**CITY OF WOODLAND PARK  
BOARD OF ADJUSTMENT AGENDA  
August 19, 2019 – 6:30 pm  
Woodland Park Council Chambers  
220 W. South Avenue, Woodland Park, CO**

| <b>SUBMISSION OF CERTIFIED RECORD<br/>         IN THE MATTER OF<br/>         THE APPEAL FROM THE ADMINISTRATIVE ORDER APPROVING<br/>         SPR 19-001 THE VILLAGE AT TAMARAC SITE PLAN (the "ORDER")</b> |  |                                                                    |

| <b>CITY RESPONSE TO PAUL B. NEAL III, DAWN C. NEAL, CAROLE MOLDEN,<br/>BROOKE SMITH AND KAROLYN SMITH APPEAL<br/>IN THE MATTER OF<br/>THE APPEAL FROM THE ADMINISTRATIVE ORDER APPROVING (SPR-19-001)<br/>THE VILLAGE AT TAMARAC SITE PLAN (the “ORDER”)</b> |  |                                     |

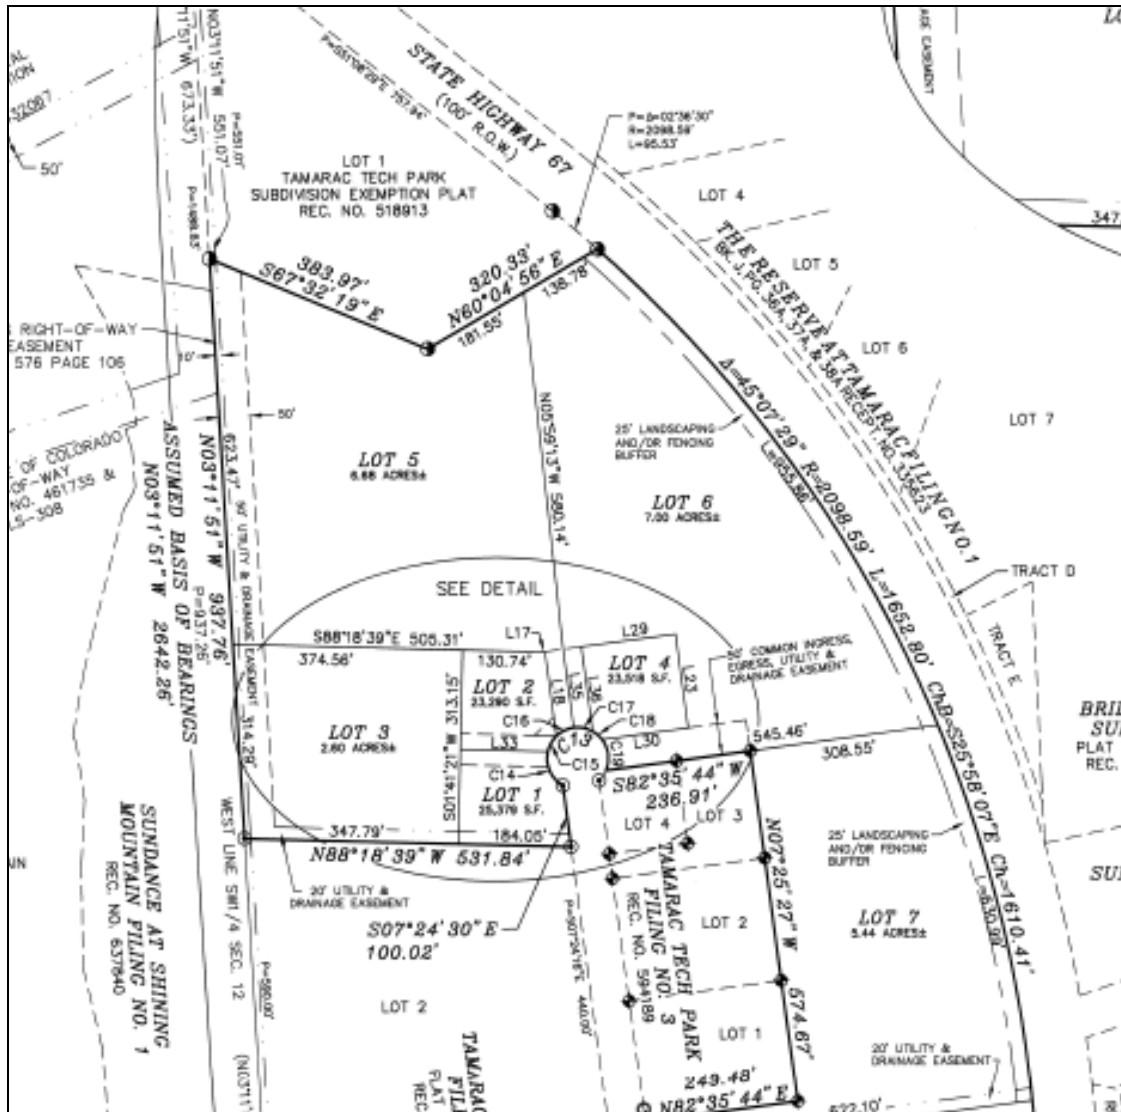
### **Petitioner's Objection (disagreement) and Request #8:**

Petitioner claims that the determination of the front lot line and setback is incorrect. The Petitioner requests that a front setback be extended beyond the flag portion to include the southern property boundary of Lot 5.

#### **➤ City's response to Petitioners Objection and Request #8**

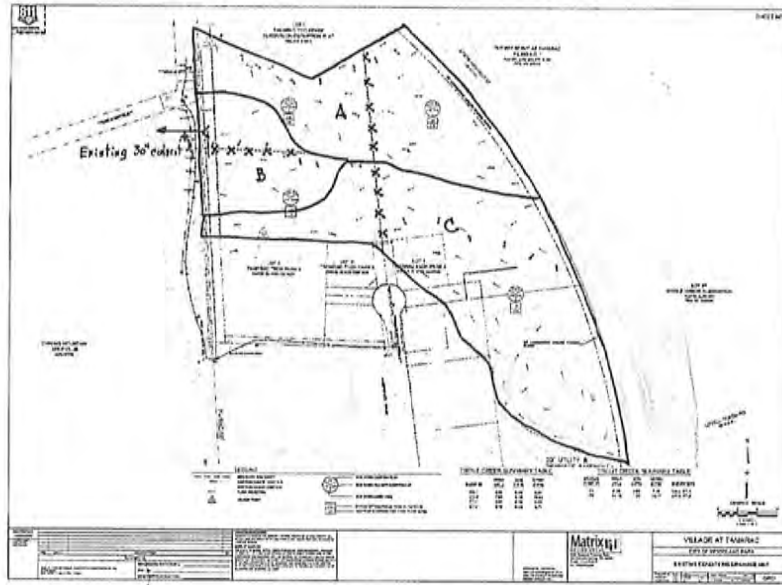
1. Basin A conveys runoff overland toward the northwest corner of the proposed development. A ridge between Basins A & B directs the historic runoff to the north side of the Sundance at Shining Mountain Townhomes development and onto the Shining Mountain golf course property.
2. Basin B conveys runoff overland to the west and into an existing 30 inch culvert through the Sundance at Shining Mountain Townhomes development. This culvert discharges just behind the 8th green on the Shining Mountain golf course.
3. Basin C conveys runoff overland to the northwest and then to the west onto the property of the Sundance at Shining Mountain Townhomes development.

The Drainage Report sizes a detention basin at the northwest corner of the proposed development with on-site drainage structures that route all developed runoff to this detention basin. Discharge from this detention basin is shown on Drawing DP02, Proposed Conditions Drainage Map as an outlet structure to be located just east of the existing 30 inch culvert, as described in paragraph 2. above. This arrangement will direct all drainage flows from the proposed development through this culvert. *Comment: If the historic drainage patterns as shown the Attachment are correct, runoff from Basins A, B & C (after detention) would be directed to and through the existing 30 inch culvert. By observation, this culvert currently handles only the historic runoff from Basin B. This historic runoff is quite low due to the small size of Basin B and the highly permeable existing soils. An examination of the ground at the outlet of the existing 30 Inch culvert shows little evidence of historic discharge.*

In conclusion, it seems questionable that flows from the proposed development are following the historic drainage patterns. It also seems that the existing 30 inch culvert is being proposed to handle all runoff from the developed property when historically this culvert only handled a small portion of the runoff.

SP01

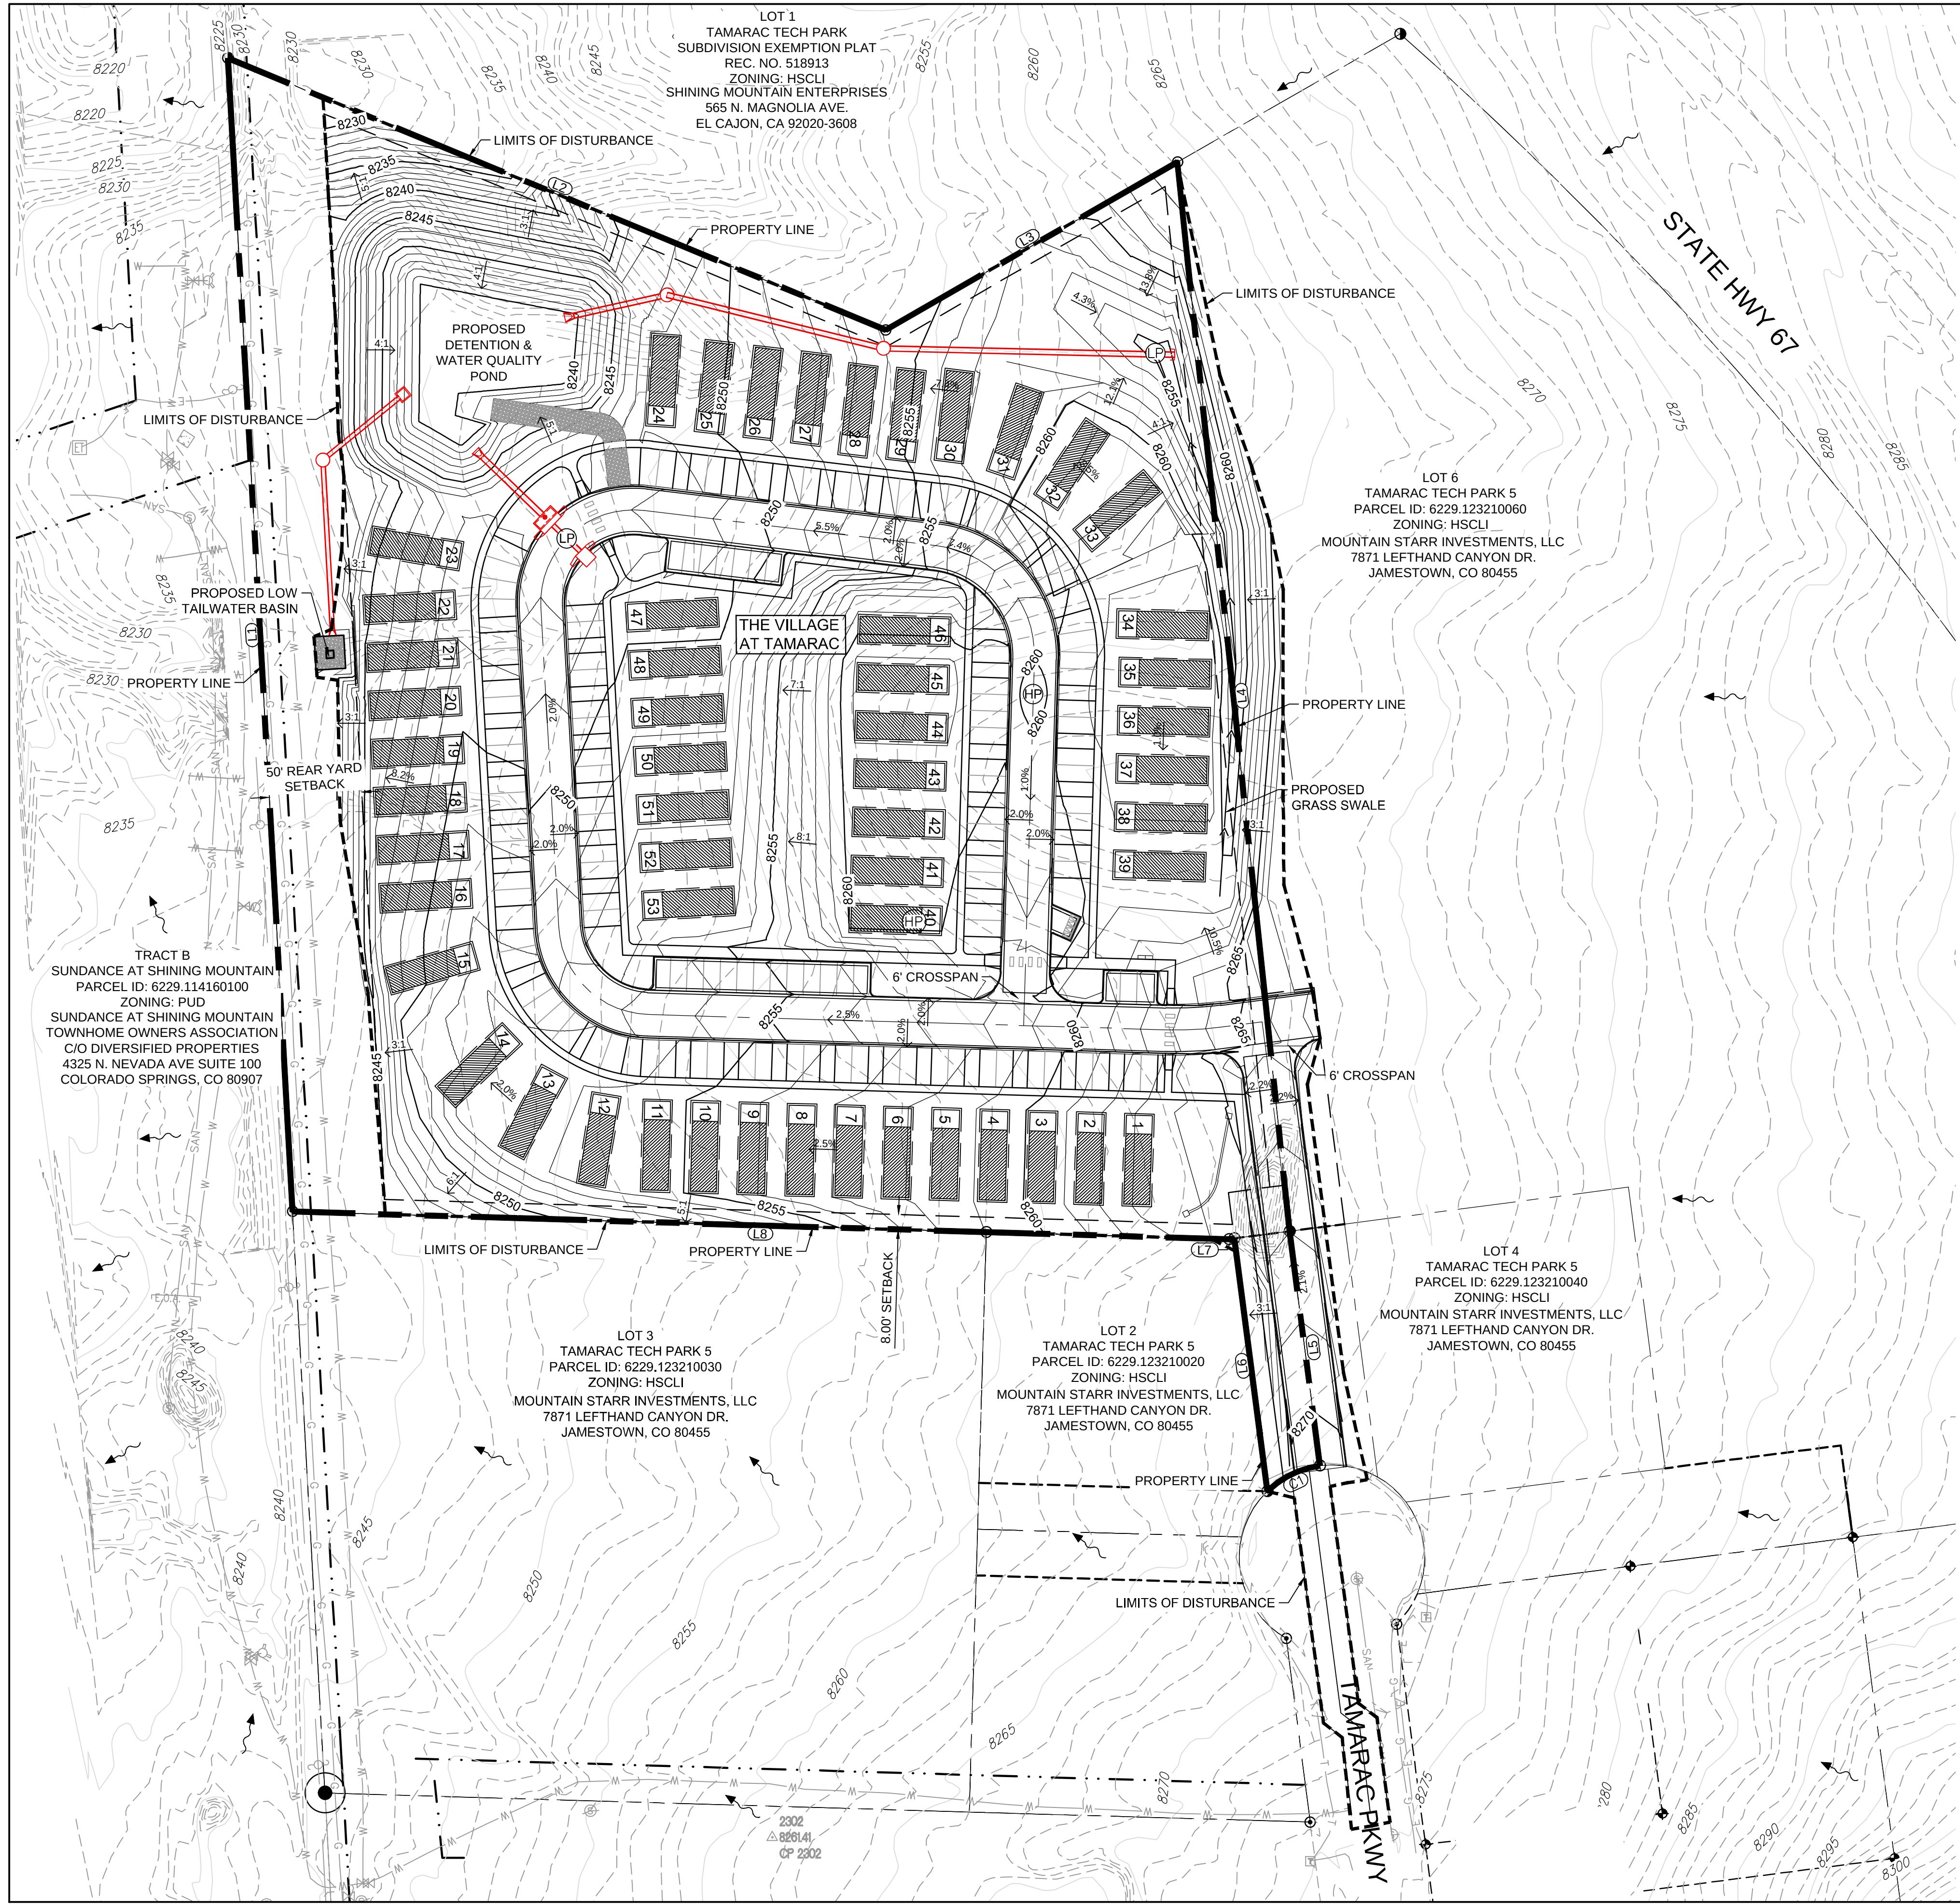
3. 18.14.060 - Frontage. There shall be a minimum lot frontage in the MFS district of 40 feet as measured at the street line. *Comment: The arc length of the property line adjoining the Tamarac Parkway cul-de-sac is shown on Drawing SP01 as 31.78 feet. Even though there is a proposed access easement of 60 feet adjoining the cul-de-sac, the actual property frontage of this proposed project is less than the 40 ft requirement of the MFS Zone.*

Comments on the general arrangement of the manufactured homes in this proposed project as shown on Drawing SPO1: When viewing this plan, the arrangement of the 53 homes seems to look like what one would expect to see in a mobile home park. But, would this proposed project meet the zoning requirements for a mobile home park? *Comment: Answer is, no it would not. Section 16.16.010 for mobile home spacing requires 15 feet between homes and at least 50 feet from exterior boundaries. This project proposes 10 feet between homes and 8 feet to the exterior boundaries on three sides of the development.*
